**Re: IFB 26C726001 Gilroy CVEF S/B & N/B - Security Camera and CCTV Installations
ADDENDUM #2 – Questions & Answers, Revised Scope of Work**

Enclosures: Exhibit A- Scope of Work – Revised (7 pages)
Attachment 1 – Gilroy CVEF S/B and N/B Interior and Exterior Maps drawings (4 pages)

SOUTHBOUND INTERIOR – CCTV CAMERA LOCATIONS

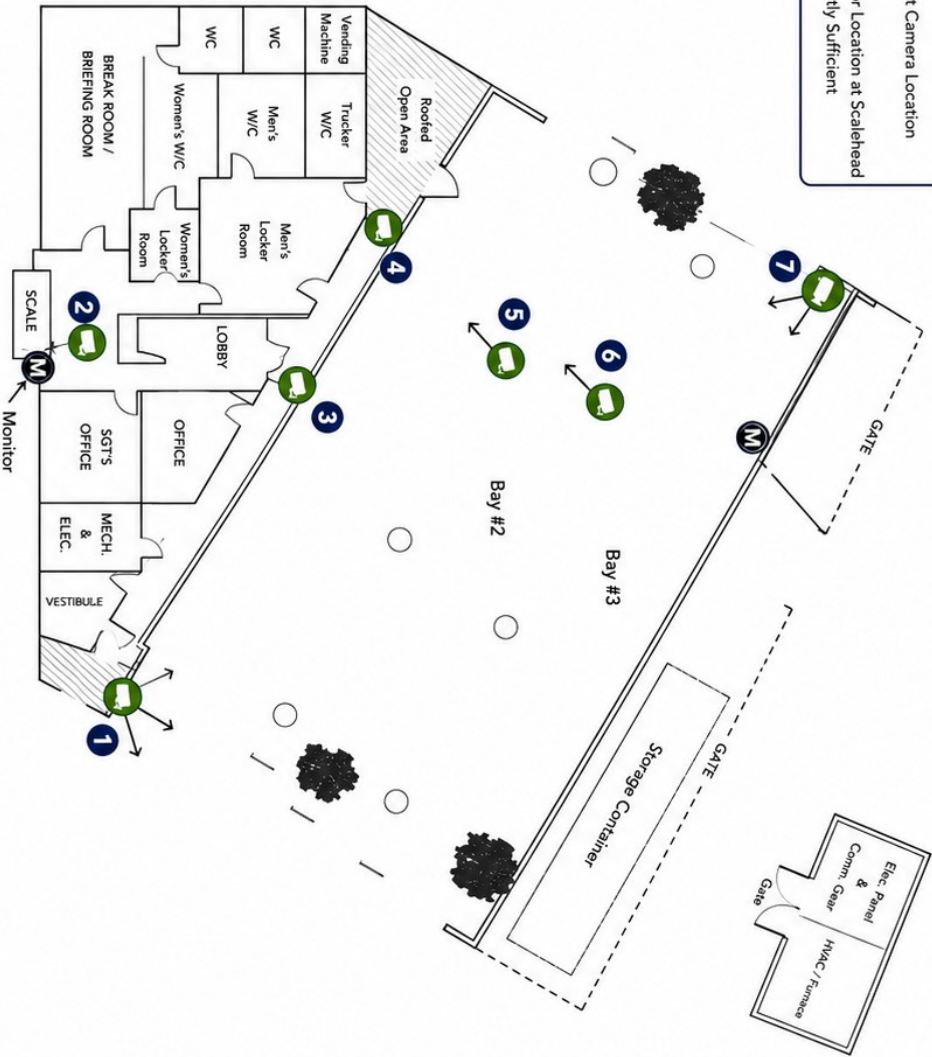
- a. Please provide the complete list of all five Item B camera locations including room or area designation for each
- b. Whether an addendum will be issued correcting the camera specification at any exterior or wash-down wall locations
- c. Whether replacement of existing cameras at unaddressed locations is included in this scope of work, and if so please provide the required camera model and specifications at each location and confirm whether an addendum will be issued to include these locations. The specified P3275-LV is not appropriate for exterior or wash-down environments and the remaining unspecified cameras in the current BOM would not adequately address these locations.

- All camera locations are as depicted on the plans.
- The Contractor shall verify all existing camera locations are operational and provide proper coverage.
- The Contractor shall provide and install (1) new interior camera at Location 1 and integrate it with the CCTV system.
- Final camera angles shall be adjusted during installation to optimize coverage and minimize blind spots.

NORTHBOUND EXTERIOR CCTV CAMERAS

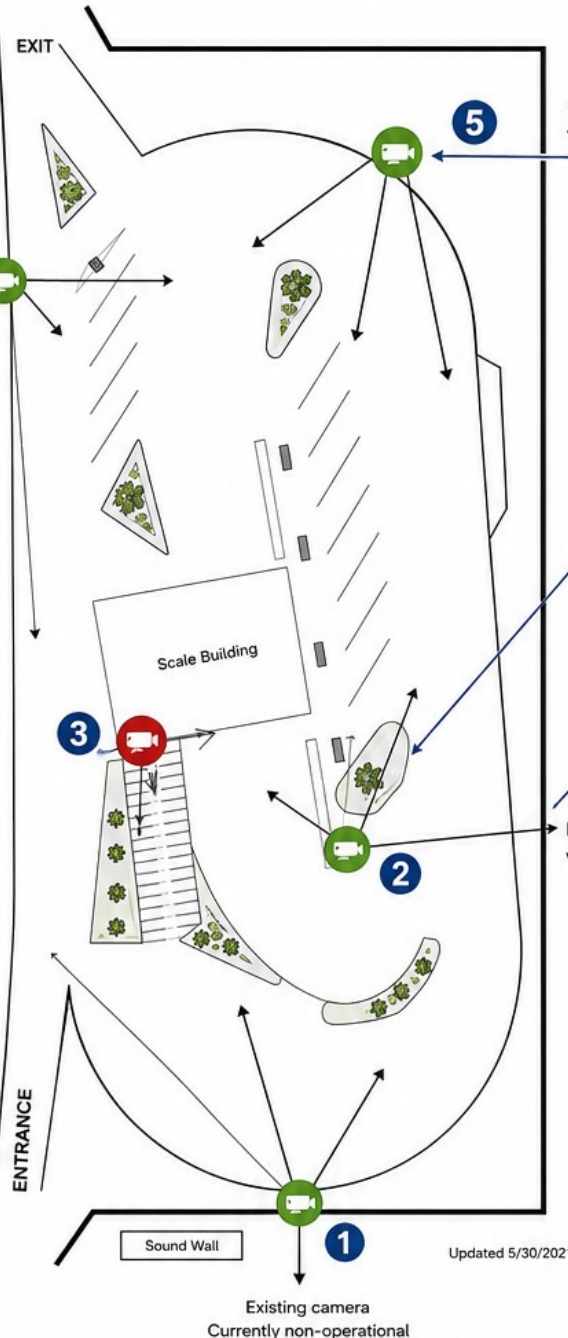
Please confirm in writing whether the camera assemblies specified under Items A and C constitute the complete exit monitoring solution under this contract, or identify the specific CHP-owned structure designated for a dedicated exit camera installation and the method by which power is to be provided.

The Contractor shall furnish, install, configure, test, and place into service five (5) exterior CCTV cameras at the Northbound Gilroy Inspection Facility. The cameras shall be installed at the following locations, as depicted on the project drawings:

- 1 Main Entrance:** Install a new exterior camera at the main entrance to provide coverage of vehicles entering the Northbound Inspection Facility.
- 2 East Approach:** Install a new exterior camera on the east approach to provide coverage of the driveway and adjacent operational areas.
- 3 Scale Building / Parking:** Install a new exterior camera at the scale building / parking area to provide coverage of the scale building entrance, parking area, and surrounding operational areas.
- 4 West Approach:** Install a new exterior camera on the west approach to provide coverage of the west approach and adjacent US-101 roadway.
- 5 North Exit:** Install a new exterior camera at the north exit to provide coverage of vehicles exiting the Northbound Inspection Facility.
